SERVICE INFORMATION SHEET 219

SI 219 - July, 2022

V-Ride II (SVRII) 48V & 52V Front Caster Bolt

Figure 1. Front Axle Caster Bolt & Elastic Locking Nut

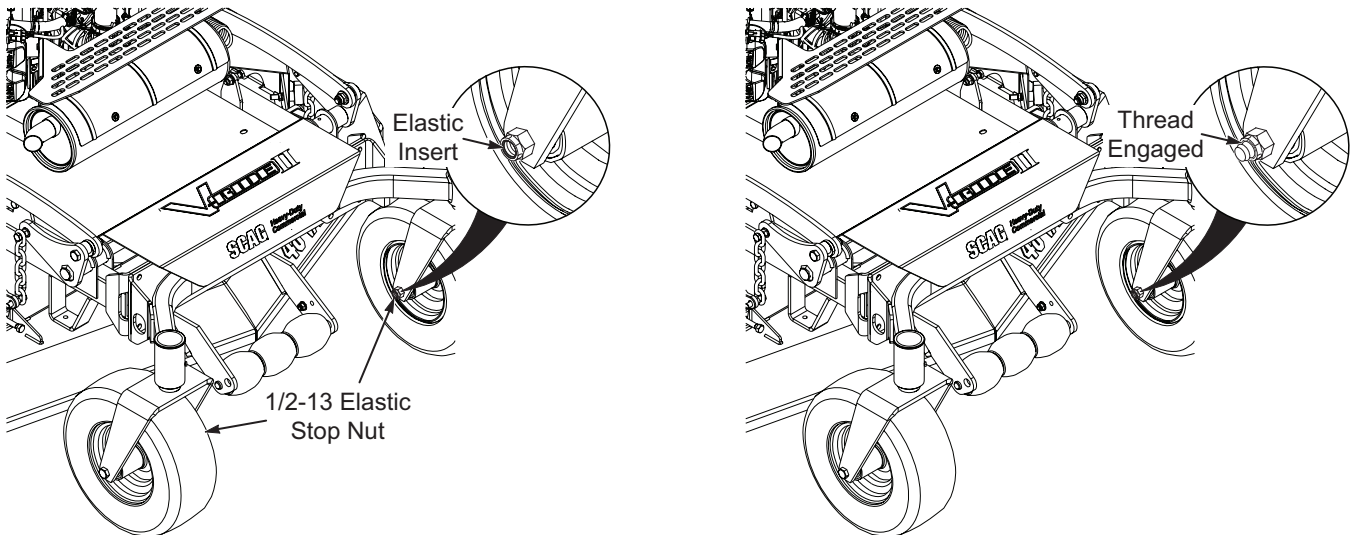
We have received reports from the field of the threads on front caster axle bolts not engaging with the elastic insert provided in the locking nuts on a limited number of SVRII-48V & 52V machines in the serial number ranges listed below.

This can be resolved by replacement of the caster axle bolts with 1/2-13 x 8" hex head bolt p/n 04001-227.
